MANDATORY SERVICE BULLETIN Z 242L/25a

1. DATE: April 25, 1997
2. MODELS AFFECTED: All Zlin 242L aircraft through S/N 0708 and S/Nos. 0727 and 0728.
3. SUBJECT: Moravan, Inc. found out that the sludge valve of the oil system Drwg. No. L 242.7100-04.00 installed on the aforementioned aircraft can have a manufacturing defect which may cause the oil leakage from the engine. There occurred the case that the wrongly locked nut loosened, the valve sealing disc dropped off and the lifter fell out from the valve body.

Fig. 1.: Sludge valve of the engine oil system
Drwg. No. L 242.7100-04.00

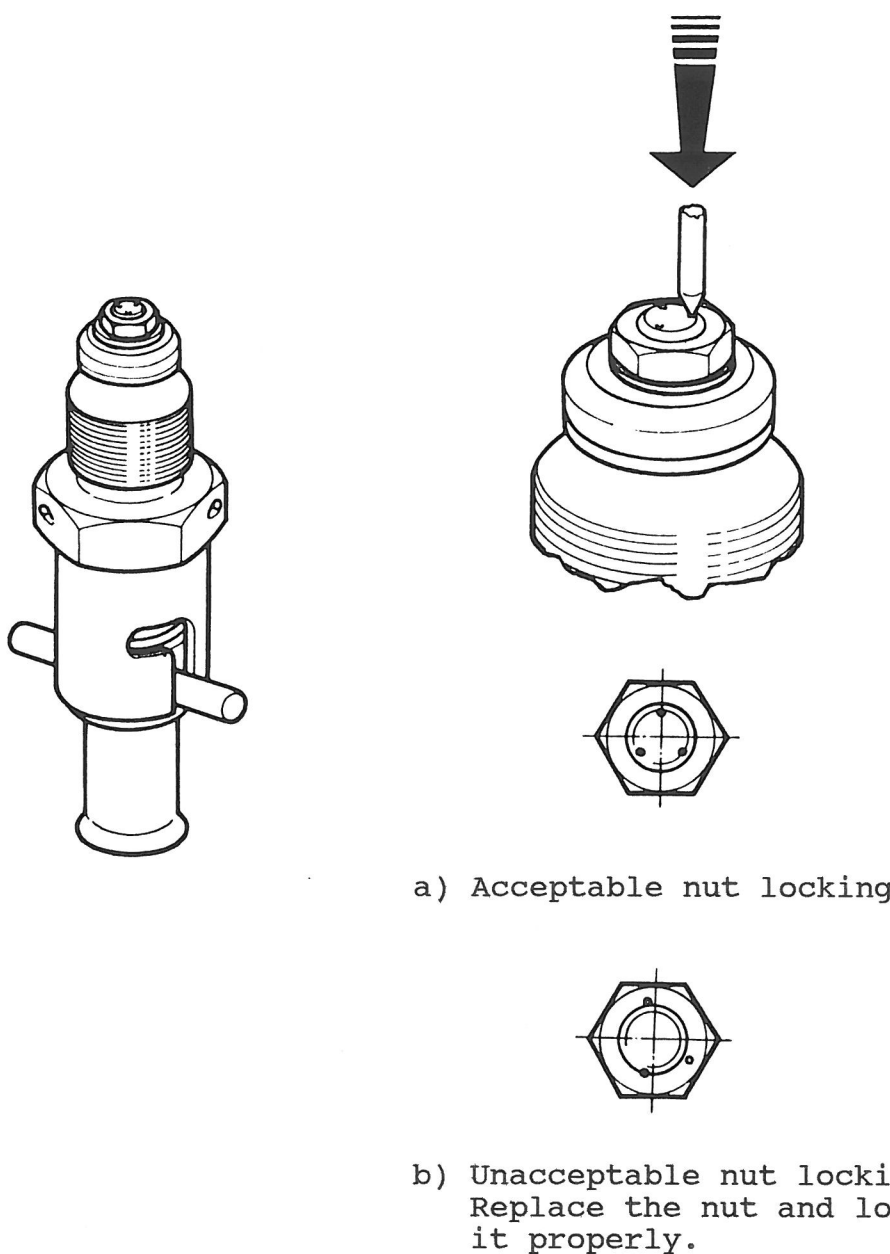
2. Check visually the nut in assembly of the lifter and the valve sealing disc for proper locking. Fig. 1 shows proper locking of the nut (by means of 3 centre punches on the periphery of the screw face). Replace the nut locked by wrong method or the damaged one and lock it properly according to Fig. 1. The rubber seal under the valve disc should be seated to be concentric with this disc.

4. CORRECTION: Check of the nut on the sludge valve Drwg. No. L 242.7100-04.00 in the oil system of the engine for proper locking.
5. TIME OF COMPLIANCE: Before further flight of the aircraft.

3. The nut secured with centre punches should be locked in addition with application of the Loctite 290 in the threaded joint. Before applying the Loctite, clean thoroughly and degrease the threaded joint. Do not use lacquer thinner or other as either one will damage the rubber seal.

Set the valve in a vertical position (with the nut up) and drop the Loctite in the threaded joint.

4. Mark the checked valve having the nut locked properly with two centre punches on the flat of the valve hexagon body, clean it and re-install on the aircraft. Check the appropriate level of oil in the engine and, if necessary, re-fill it. An entry in the aircraft log book should also be made.
